PUBLIC HEARING MEMORANDUM

SUBJECT: Petition #26-20 for a change of zone to Mixed Use 3/Transit Oriented District for portions of land located at 355 Grove Street (currently zoned BU-2) and 399 Grove Street (currently zoned BU-5), also identified as Section 42, Block 11, Lots 3 and 4

Petition #27-20 for a SPECIAL PERMIT/SITE PLAN APPROVAL construct a mixed use, transit-oriented development of residential units, office, retail, personal services, restaurant, hotel, and related commercial uses not to exceed 1,025,000 square feet of gross floor area, with residential uses comprising not less than 60% of the total gross floor area with a residential density of not less than 800 square feet per unit with not less than 560 units nor more than 620 units with special permit relief and/or waivers as follows: a development of more than 20,000 square feet of gross floor area, building height of up to 170 feet, buildings up to 11 stories, Floor Area Ratio of up to 2.5, beneficial open space of not less than 15%, increase of height of certain buildings with the Grove Street Area Corridor (to the extent necessary), and reduction in setback from Grove Street for certain buildings within the Grov

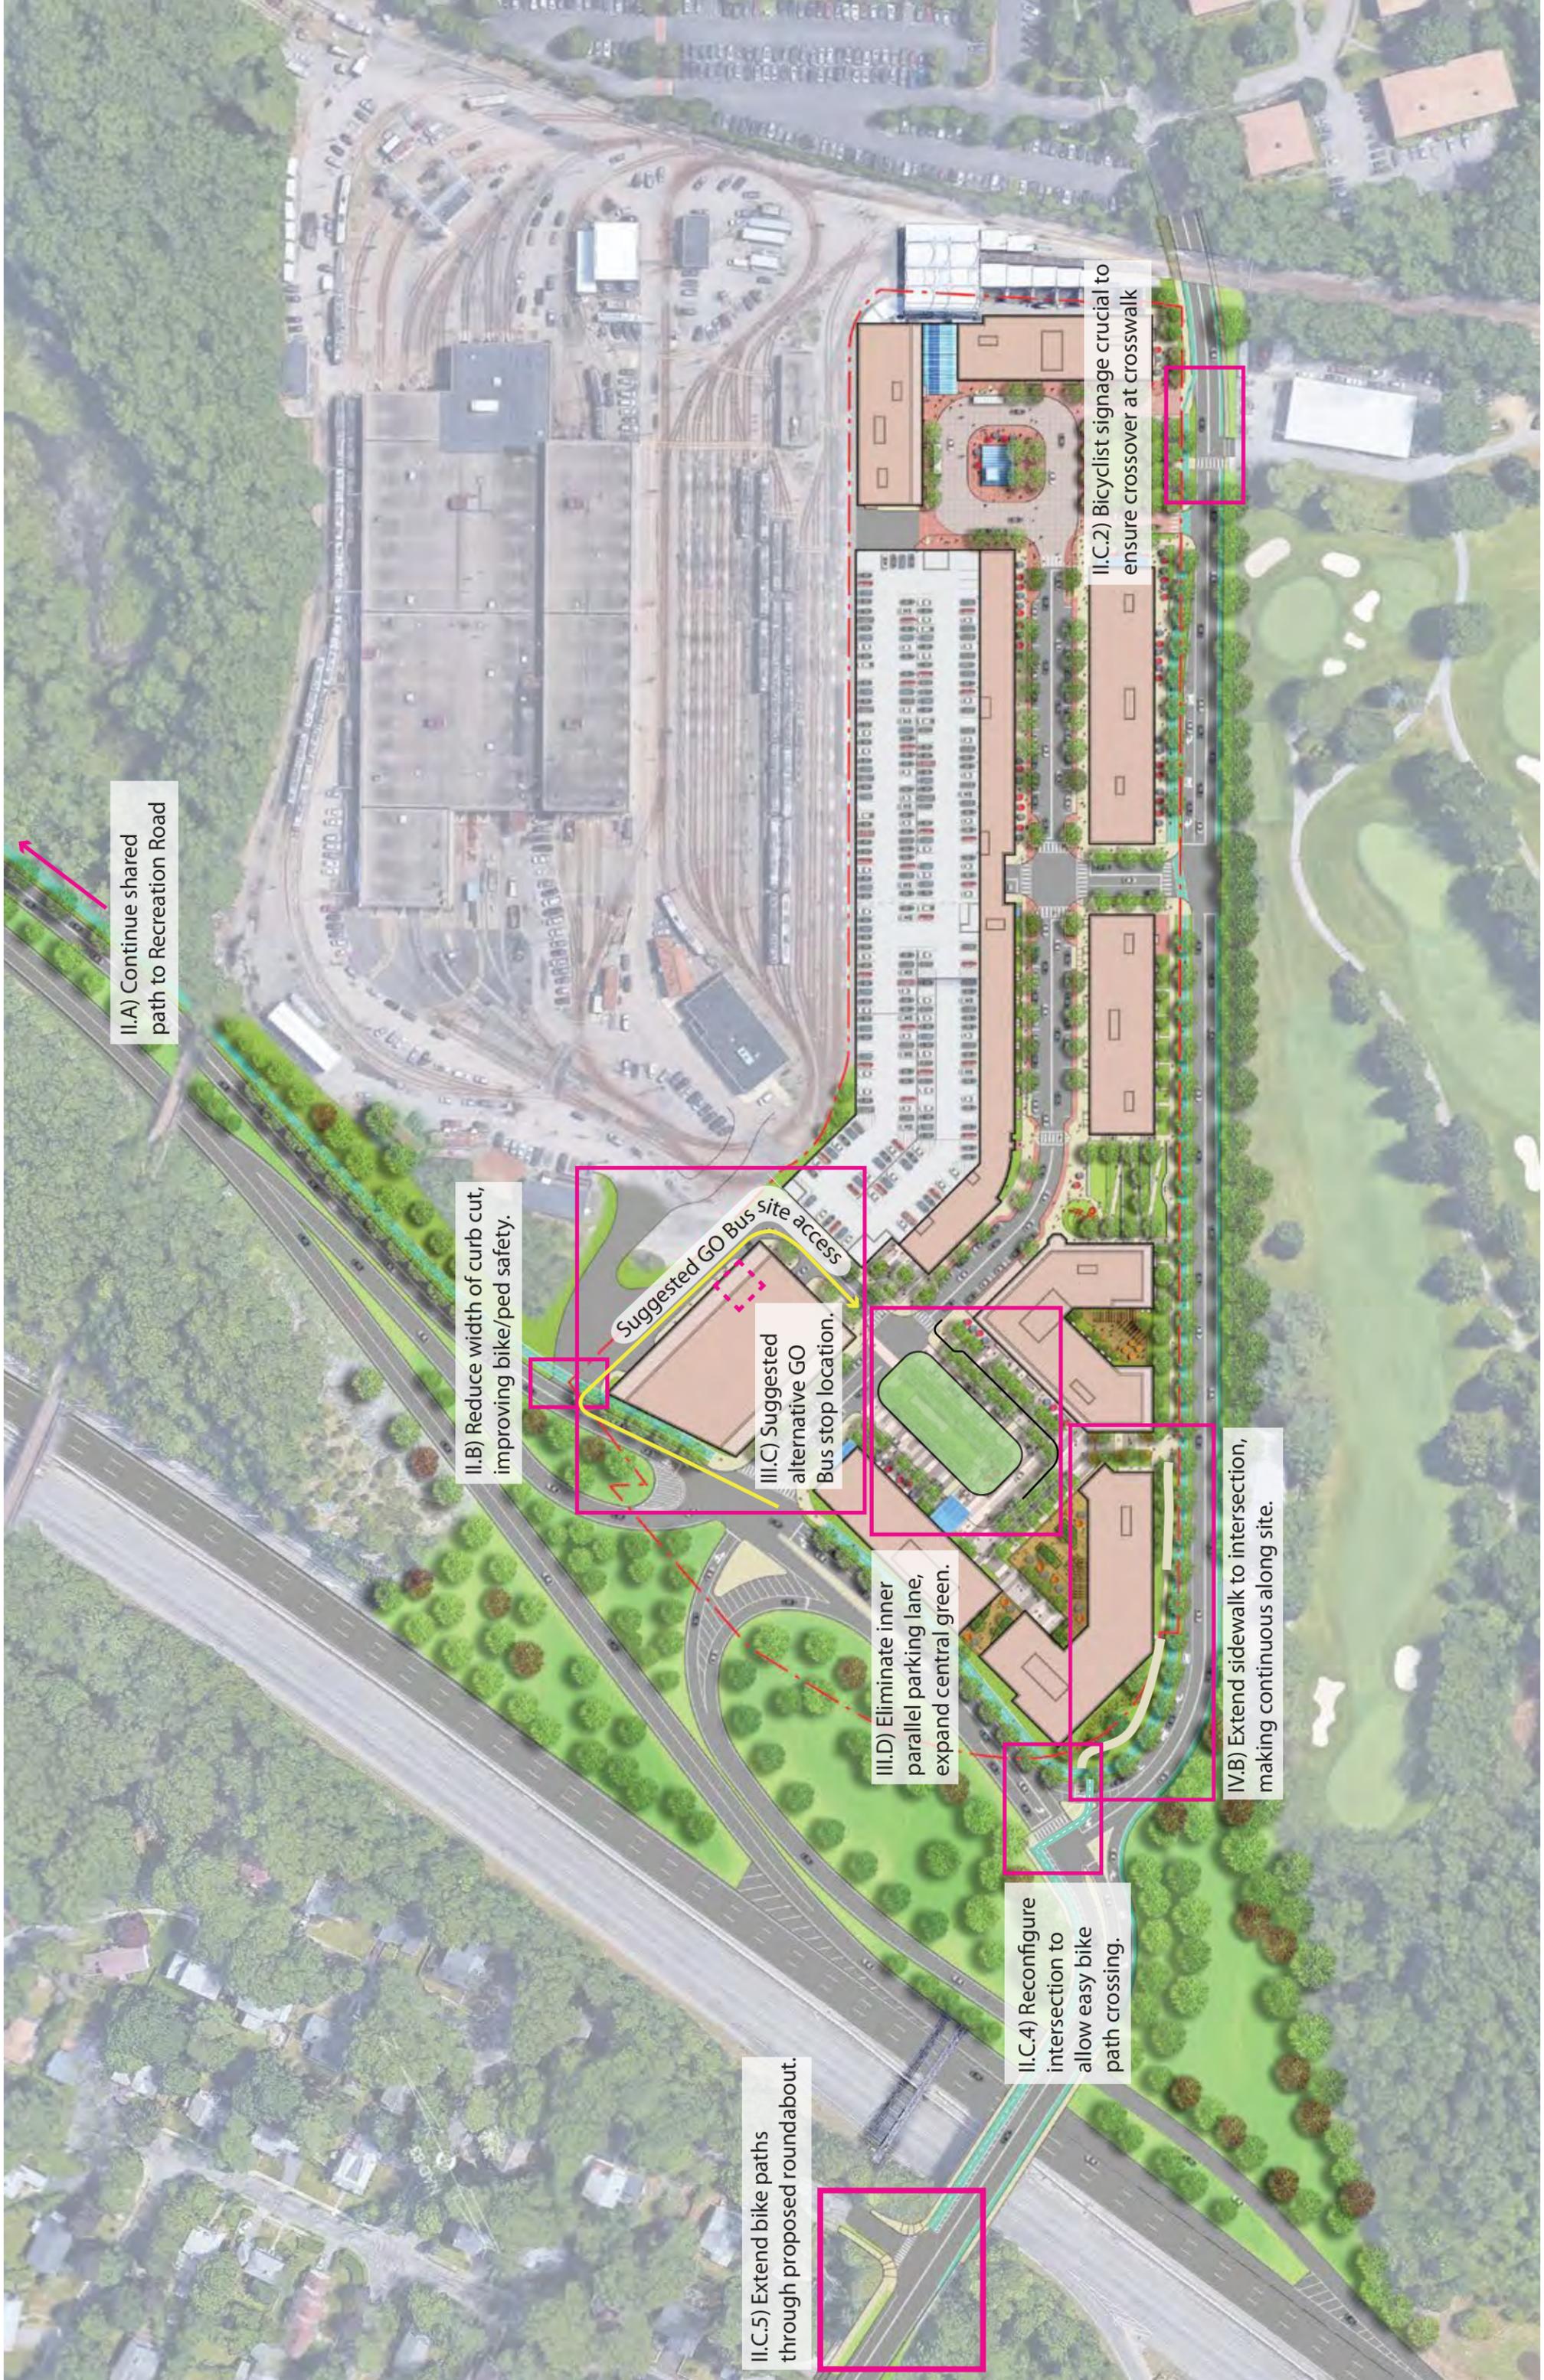
42. (U) Remove the parallel parking wrapping Hotel Green, thus creating a larger and more inviting open space that can be shared by residents, hotel guests, and office workers. On-street parking is appropriate along the building edges, but the spaces along the open space in the center will be less heavily used, and will therefore serve only to make the vehicle travel lanes seem wider and occupy space that could otherwise be devoted to usable open space. See attached diagram.

III.C) Suggested alternative GO Bus stop location.

III.D) Eliminate inner parallel parking lane, expand central green.

IV.B) Extend sidewalk to intersection, making continuous along site.

2.a) Suggested Recreation Road Access

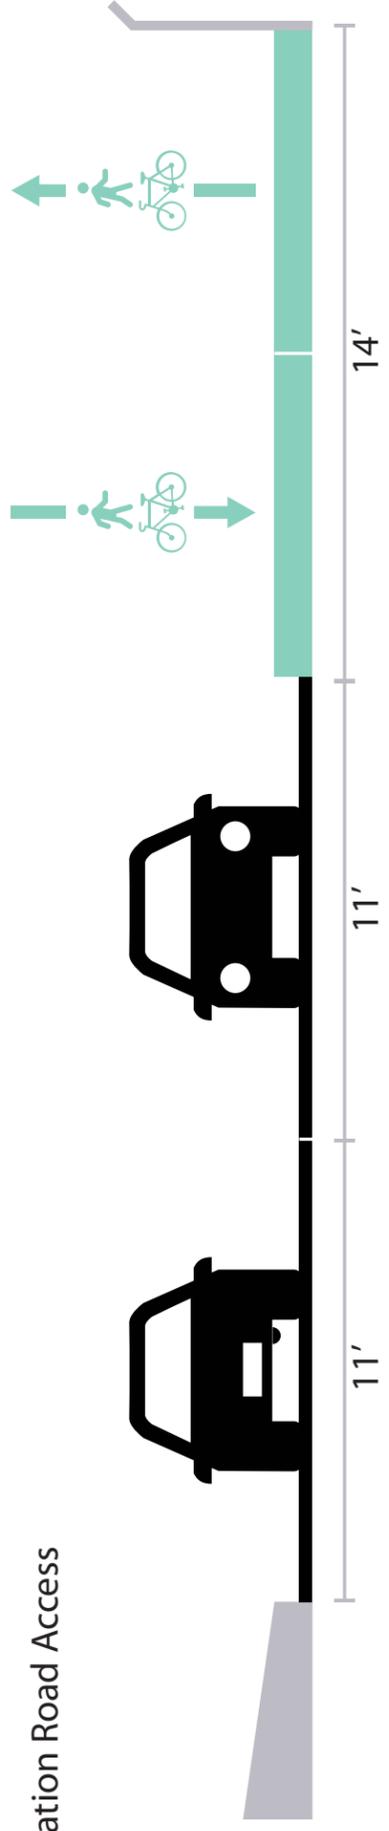
12. (U) The proposed shared-use path should be extended to Recreation Road, rather than ending at the bridge over the Charles River as currently proposed. We recommend a 14'-wide shared bicycle/pedestrian path on the northeast side of the road in order to provide two-way access for all users while ensuring separation from vehicular traffic entering and exiting the highway. This would still maintain sufficient right-of-way on the existing bridge structure for two 11' vehicular lanes. See attached diagram.

- d. At the intersection of Grove St. and the I-95 exit ramp, a pedestrian crosswalk is proposed, but the two-way bicycle path does not have a dedicated space for crossing. In order to provide safe and adequate space for both bicyclists and pedestrians, the bike path should continue across both the exit ramp and the right turn lane from Grove Street parallel to the pedestrian crosswalk, with sufficient space in the refuge island for both bicyclists and pedestrians making the two-stage crossing. See attached diagram.

II.C.2) Bicyclist signage crucial to ensure crossover at crosswalk

II.C.5) Extend bike paths through proposed roundabout.

(HW) The Proponent indicated that these connections will be made, but have not yet been fully designed or added to the plan. Additional information should be provided for review as soon as it is available.
